**City of Portales  
Blackwater Well Field  
Well Equipping Phase 2**  
ITB#: 2021-11-14  
WTB 5104-WPF

**ADDENDUM NO. 2**

December 10, 2021

SHEET 12 OF 15  
DWG NO. E-3

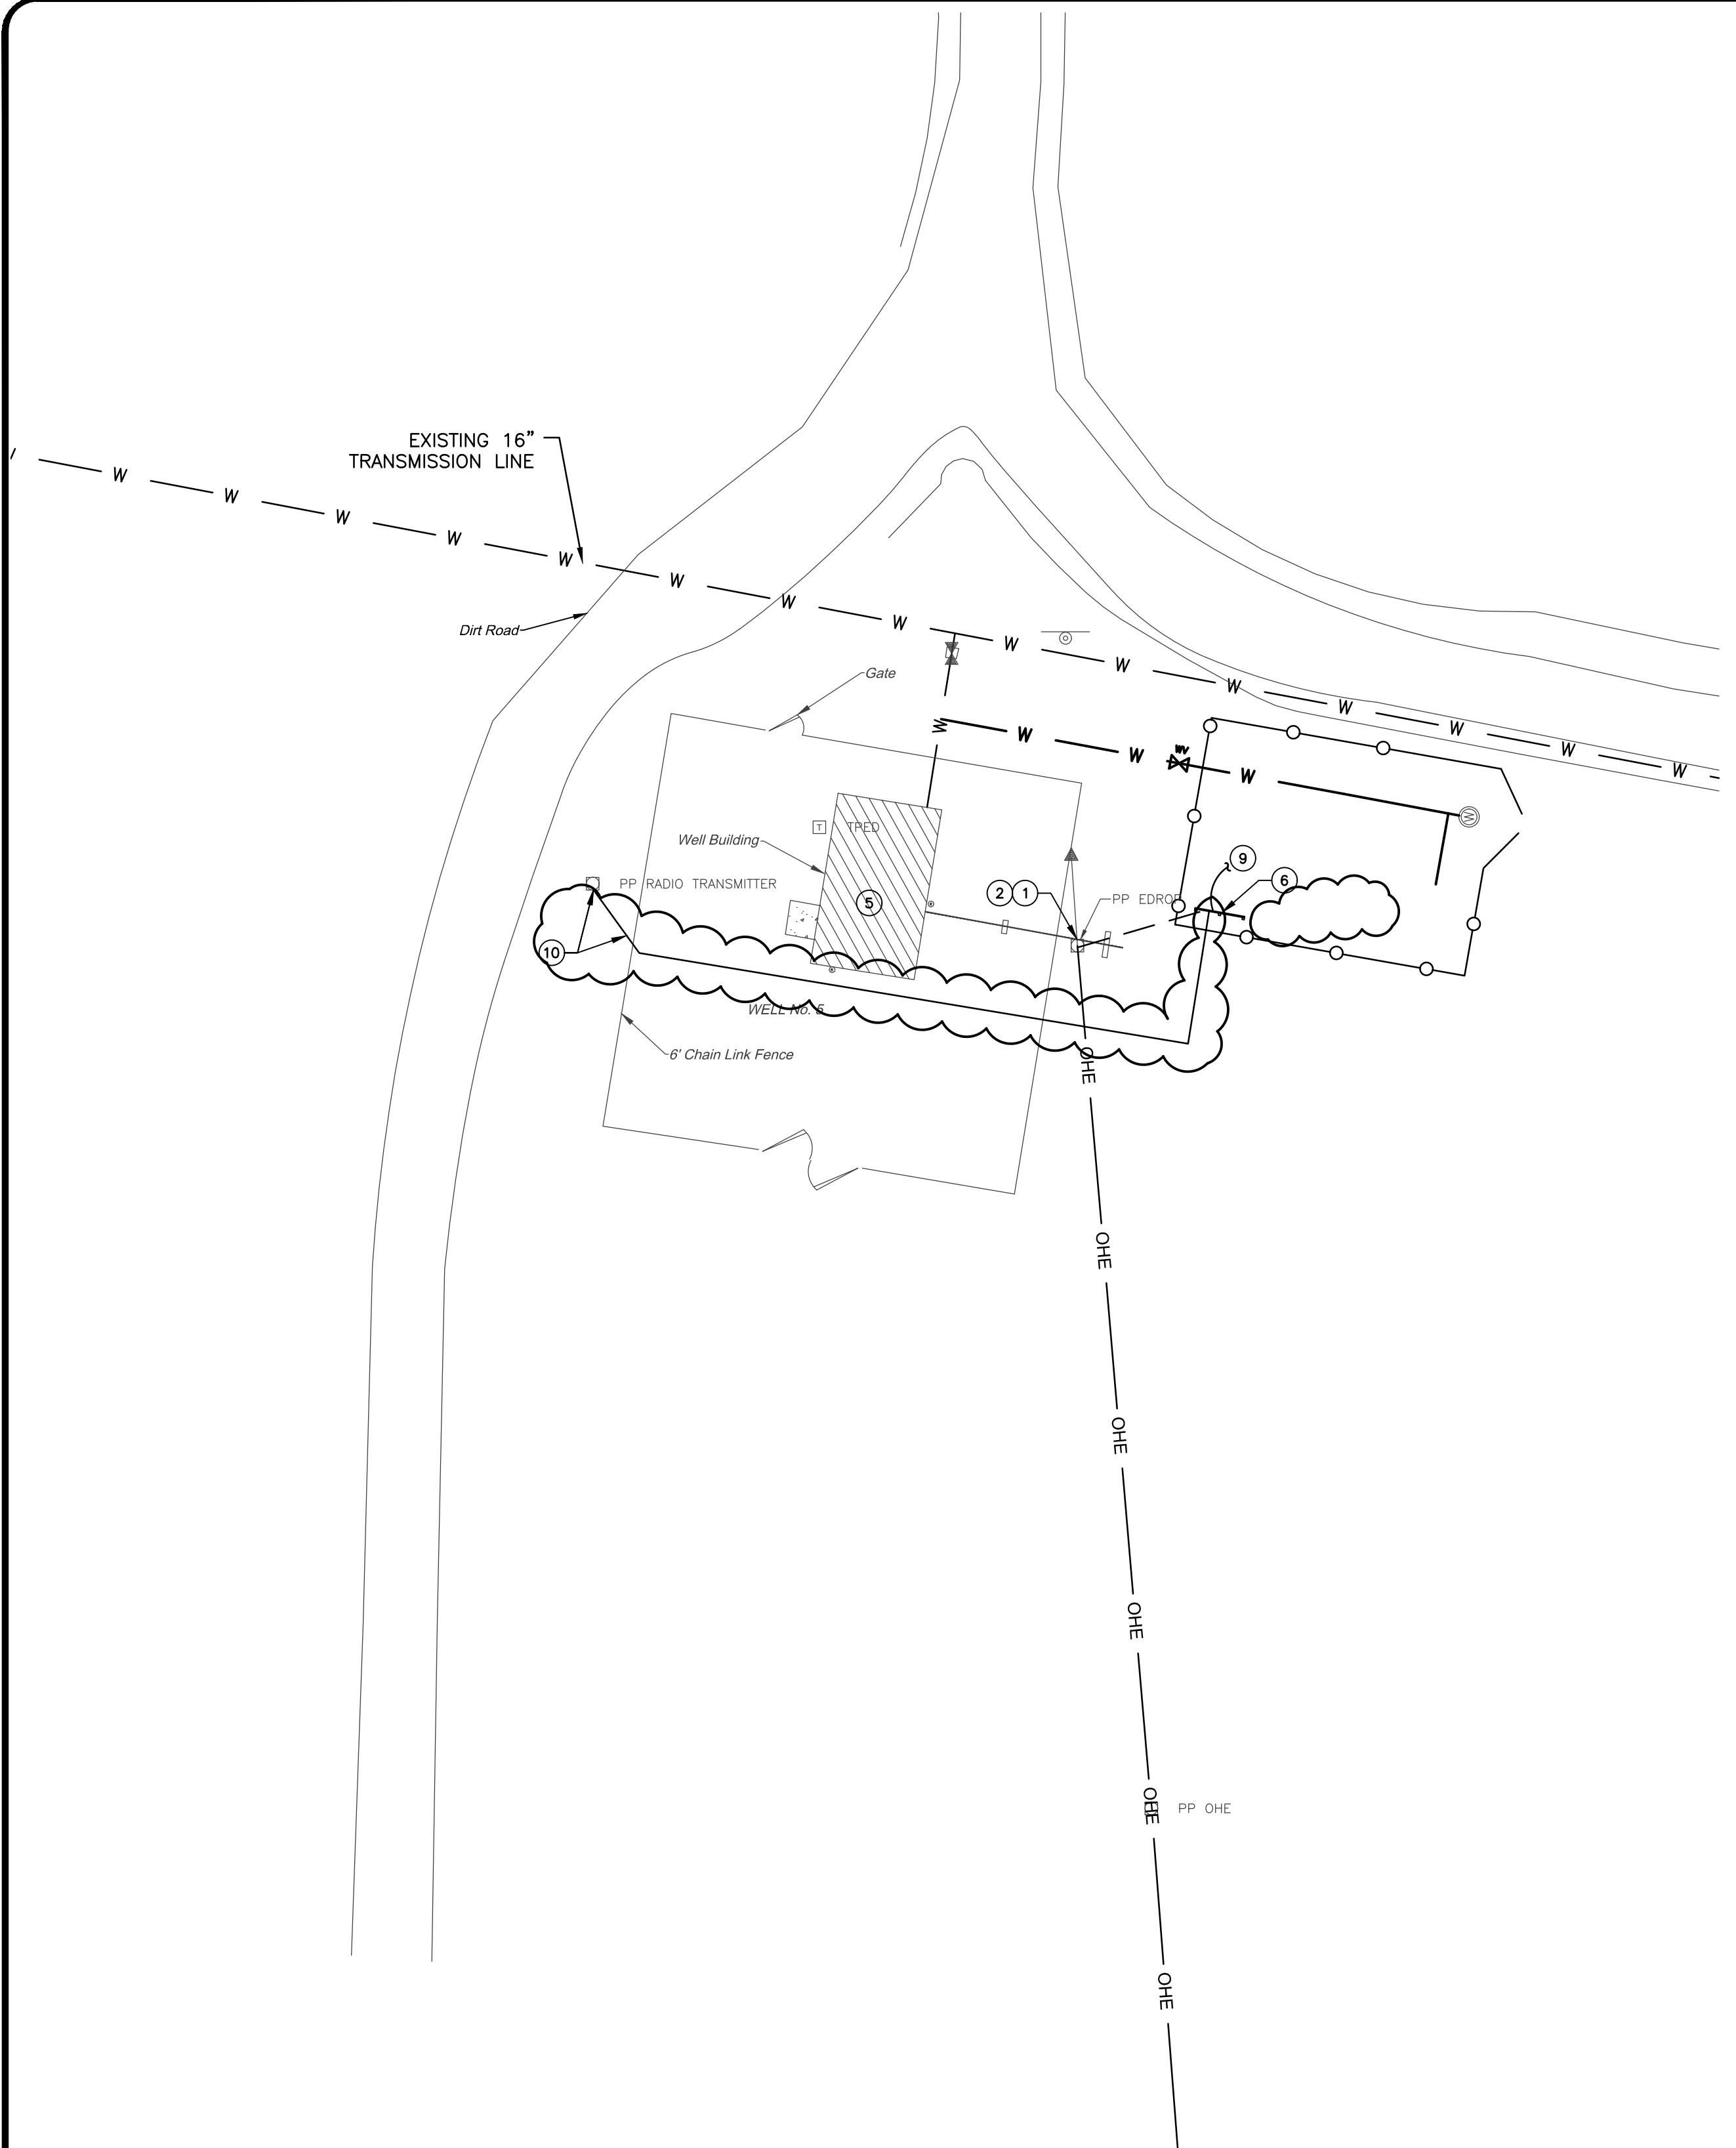
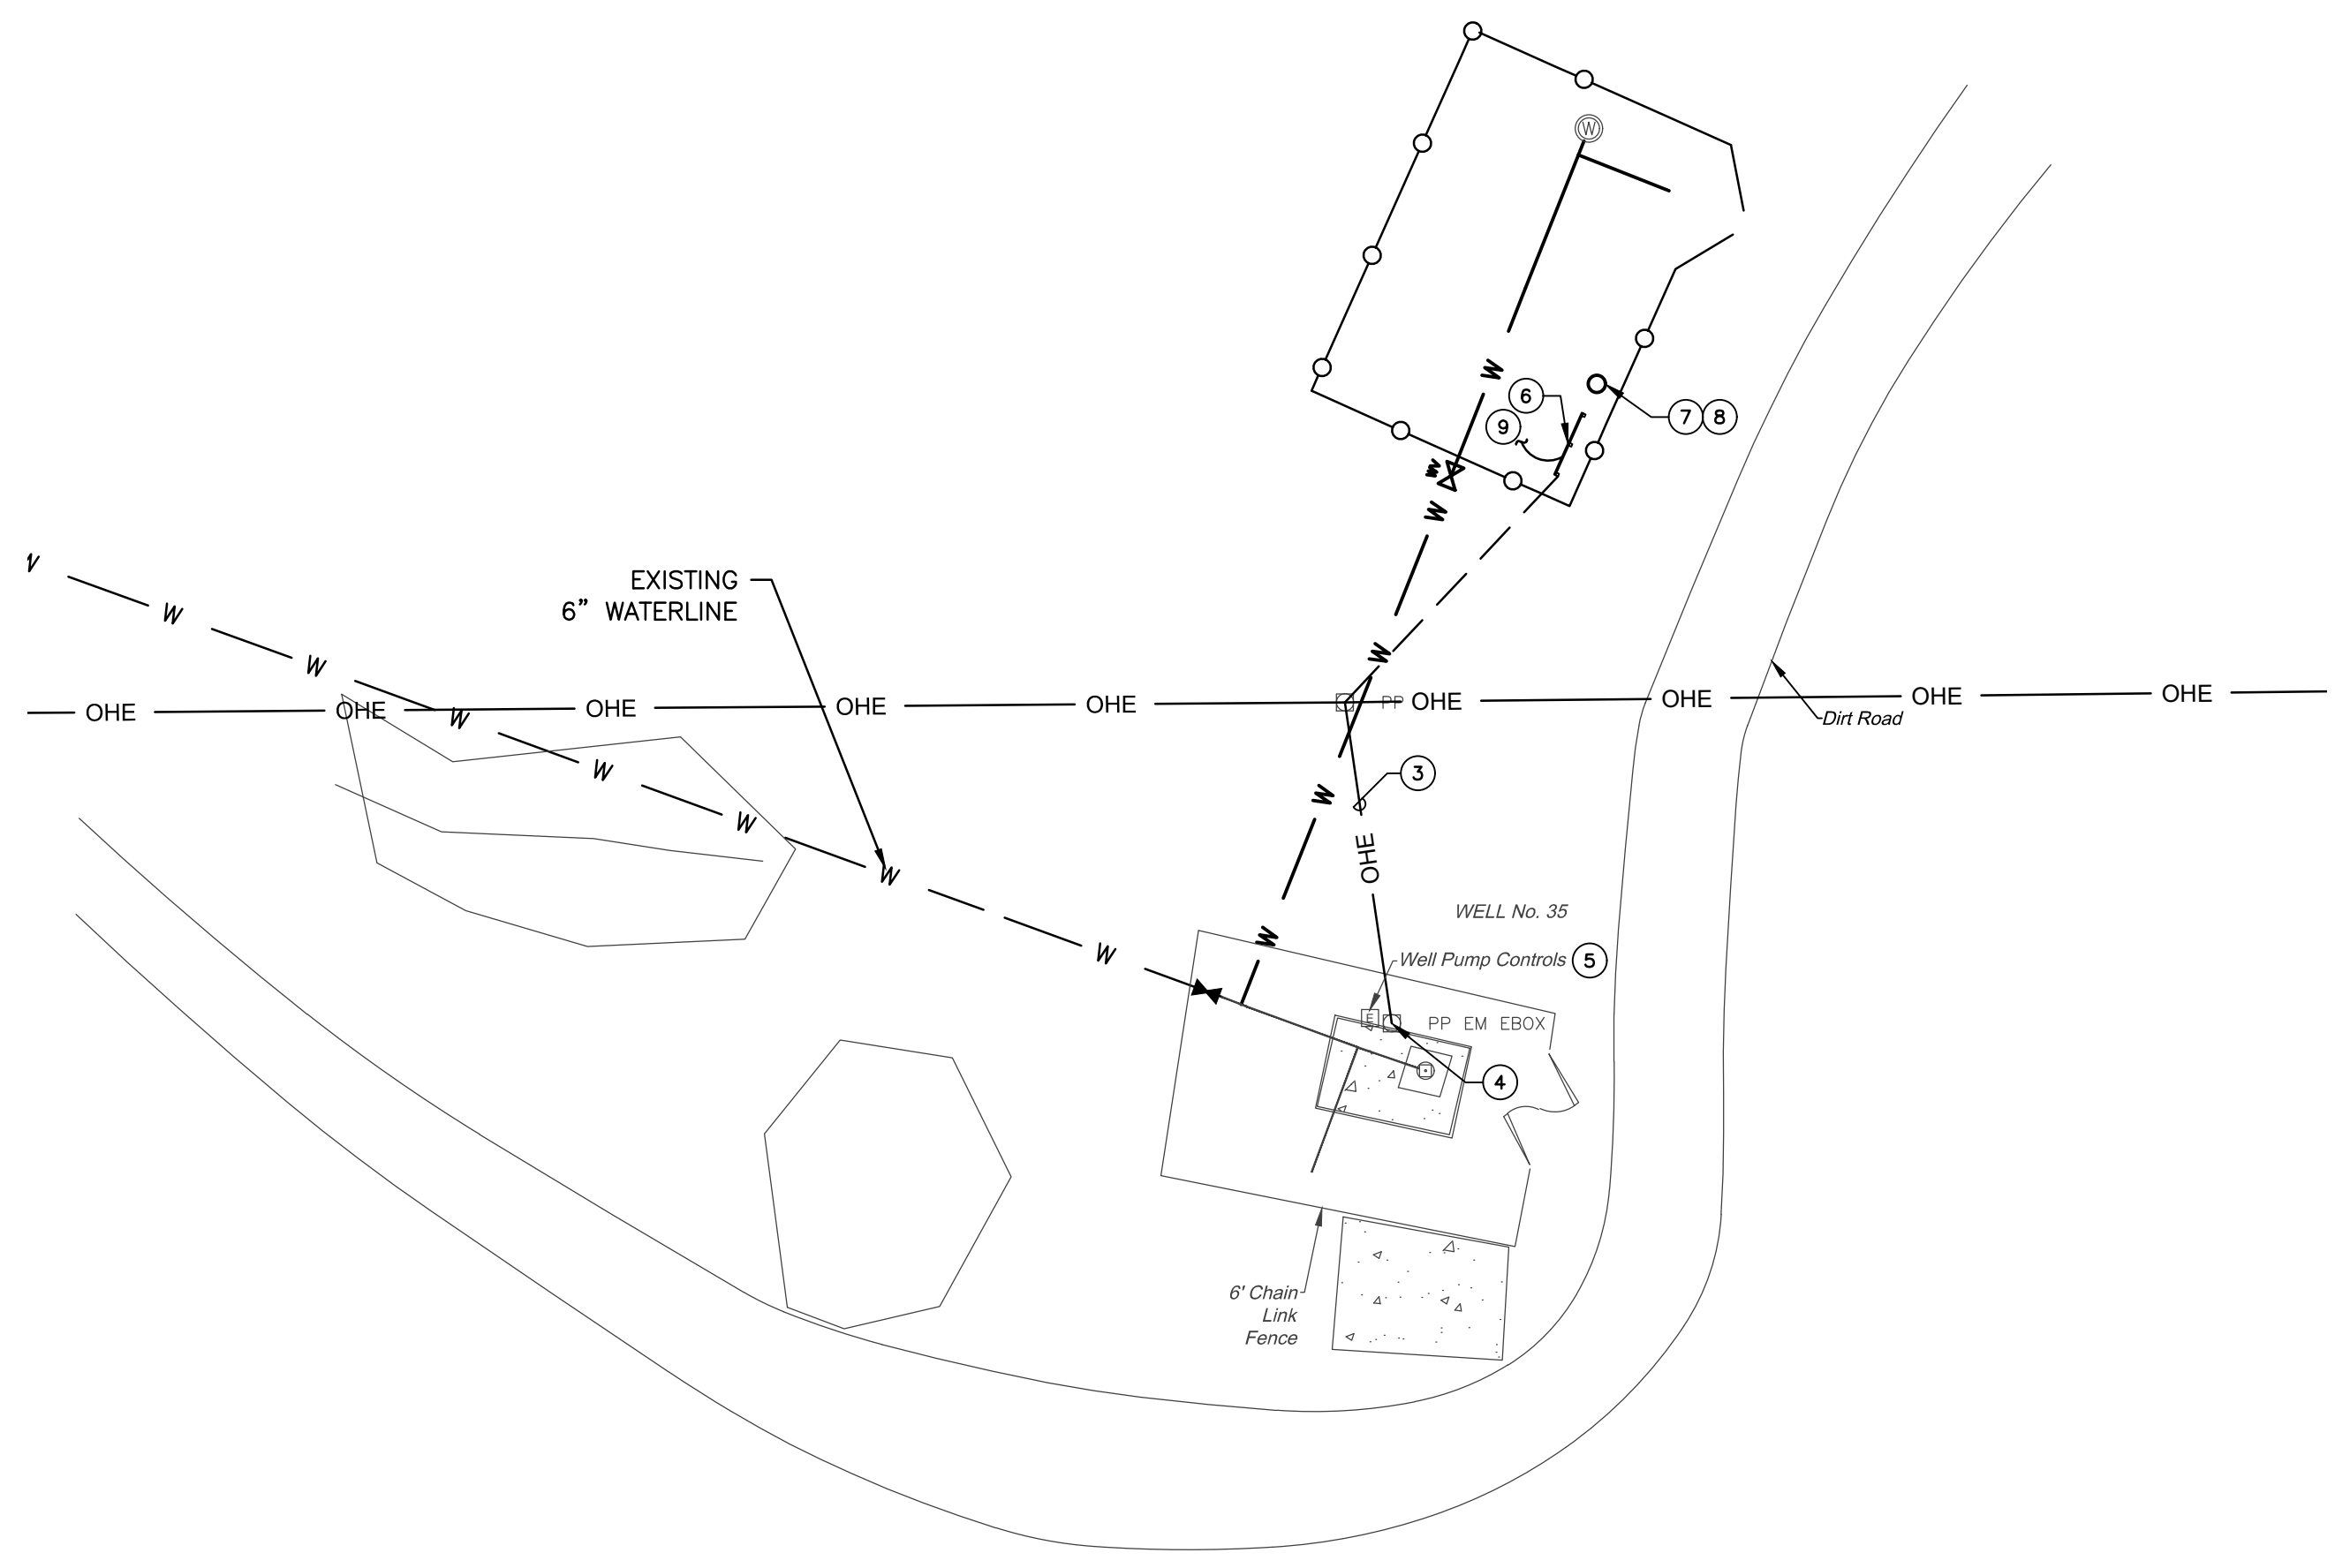
1. On the SCADA drawings for well B5, we are missing something to replace the cable from the existing pole that has 3 each 120 degree sector antenna and 1 dish to the new site. *Drawings E-3 and E-5 have ben revised to address this issue.*

Revised sheets E-3 and E-5 are attached.

- EXISTING POLE AND ANTENNAE. CONTRACTOR SHALL REMOVE EXISTING UBIQUITI CABLING, CUT EXISTING CONDUIT NEAR POLE BASE, PROVIDE AND INSTALL WEATHERPROOF JUNCTION BOX, AND EXTEND 1-1/4" CONDUIT TO NEW RTU LOCATION. PROVIDE AND INSTALL FIVE(5) OUTDOOR RATED, UBIQUITI ETHERNET CABLES (WITH RJ45 CONNECTORS AND GROUND WIRE). FOUR(4) FOR EXISTING ANTENNAE AND ONE(1) SPARE CABLE FOR FUTURE USE. COORDINATE ROUTING IN THE FIELD. CABLE LENGTH AS REQUIRED.
